**MS-12-00092:** Grand Addition No. 2, a minor subdivision/replat of Lot 1 and Lot 30, Grand Addition. A four-lot division located at 3400 and 3401 Aldrich Street. Submitted by Dean Grob for Jerry Willis, Grand, LLC, property owners of record.

**ADMINISTRATIVE DETERMINATION:** The Planning Director approves the Minor Subdivision for Grand Addition No. 2, subject to the following conditions:

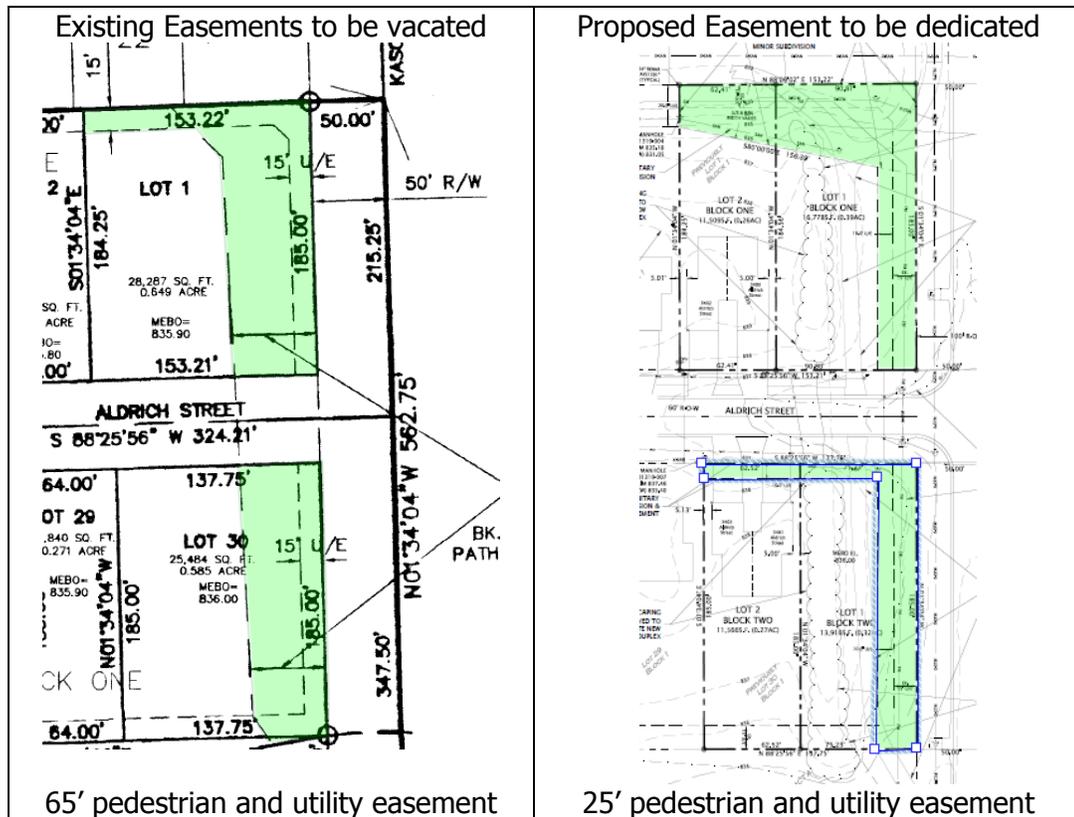
1. Provision of an executed Master Street Tree Plan per Section 20-810(g) per the City Horticulture Manager's approval.
2. Provision of a revised Minor Subdivision plat with the following changes:
  - a. Provide a note on the face of the drawing to indicate the date of approval and the specific variance granted.
  - b. Provide additional dimension along the east side of Lot 1, Block 1 to dimension the new utility and pedestrian easement. Show distance from Lot corner to south end of easement.

2012 from the requirement in Section 20-810(e)(5)(i) to provide 150 ft of right-of-way for a principal arterial to allow the Kasold Drive right-of-way to remain at 100 ft at this location. This variance should be noted on the plat prior to recording the drawing with the Register of Deeds Office.

In addition to public streets, sidewalks are also required on both sides of a street per Section 20-811 (c). This project includes a variance from providing a sidewalk along the south side of Aldrich Street. The City Engineer indicated he would have no objection to a variance from the requirement to construct a sidewalk along this street segment. The Planning Commission will consider the variance at their meeting scheduled for September 24, 2012 from the requirement in Section 20-811(c) to provide a sidewalk on both sides of the street. This variance should be noted on the plat prior to recording the drawing with the Register of Deeds Office.

The existing recreation path, located in the existing easement will be relocated into the existing right-of-way at the developers expense with this project. Some additional dimension of the drawing is recommended to clearly identify the new utility and pedestrian easement.
